Proposed amendments: Three Moon Creek Interim Resource Operations Licence

November 2020

Figure 1: Proposed operational release rules indicating when and how much can be released based on the storage volume

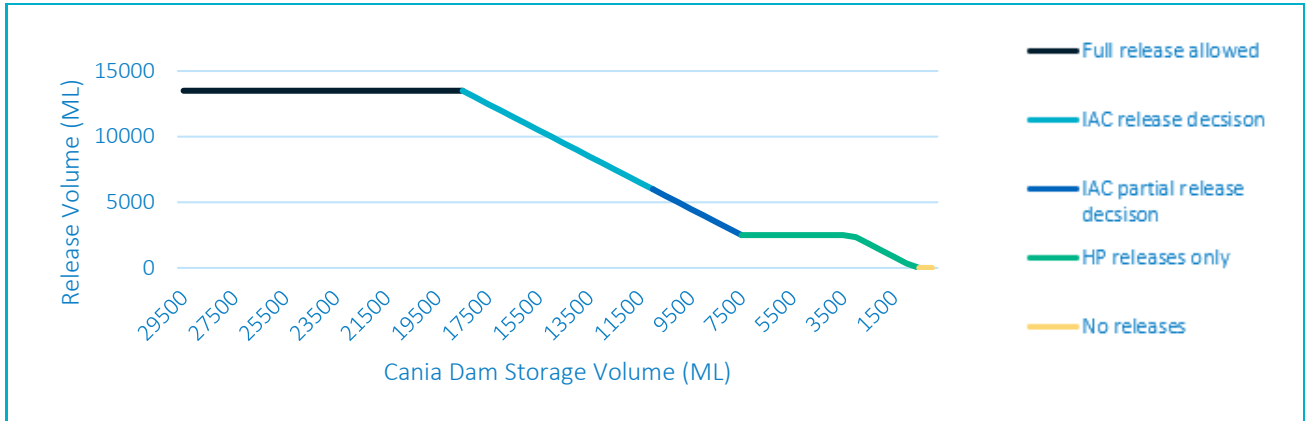
In consultation with scheme irrigators, DNRME is proposing a more flexible arrangement to the release rules to allow for water to be stored in the aquifer, where possible, while still allowing the IAC to make the release decision. The full release of 13,500 ML will remain available, but the release level threshold has been reduced to 18,500 ML (EL 316.34 mAHD or 21%). When the level in Cania Dam falls below 18,500 ML, the IAC can make a partial release of anywhere from 2,500 ML to 13,500 ML, based on the level in the dam. This release can reduce the volume in the dam down to 5,000 ML. However, if the level in Cania Dam is below 7,500 ML (EL 310.31 mAHD or 8.5%) at the start of the water year, all water in the dam is reserved for high priority use. In this scenario, up to 2,500 ML may be released for high priority per year. This reserve allows for two high priority releases (i.e. two consecutive years), with the understanding that the dam level can be drawn down to dead storage. Figure 1 demonstrates the proposed maximum releases allowed based on the dam storage volume.

Figure 2: Proposed indicator trigger levels for AA in Cania Dam

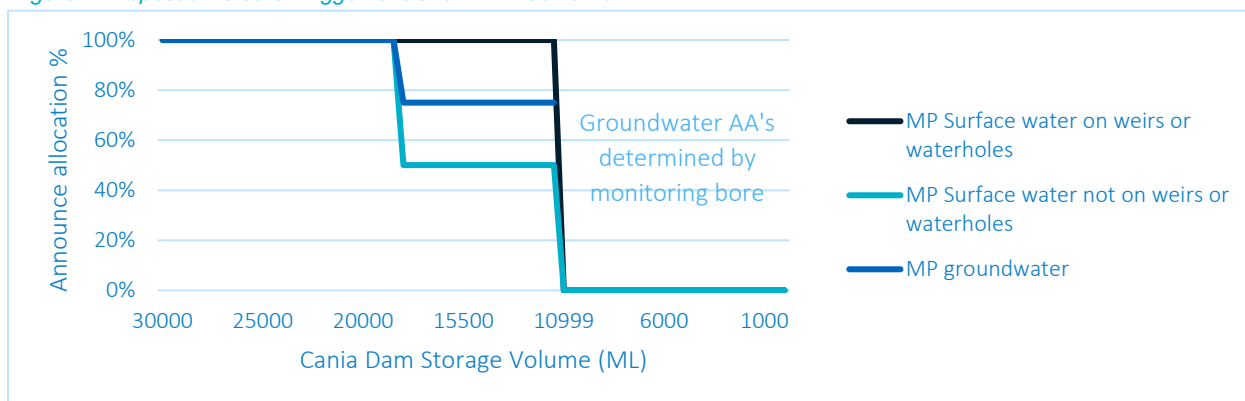
Similarly to the operational rules, the Cania Dam levels that determine AA have been reduced, as per Table 3 and graphically represented in Figure 2.

When levels in Cania Dam fall below 11,000 ML (EL 312.69 mAHD), groundwater AA will be determined by zone based on the water levels in the aquifer. Three monitoring bores per zone (as indicated in Table 4) will be used and have been assigned a target water level. If at least two of the three monitoring bores meet or exceed the target water level the AA will be 50%. If at least two of the three bores indicate below the target water level, the AA will be 25%. Once an AA has been declared it cannot be reduced.
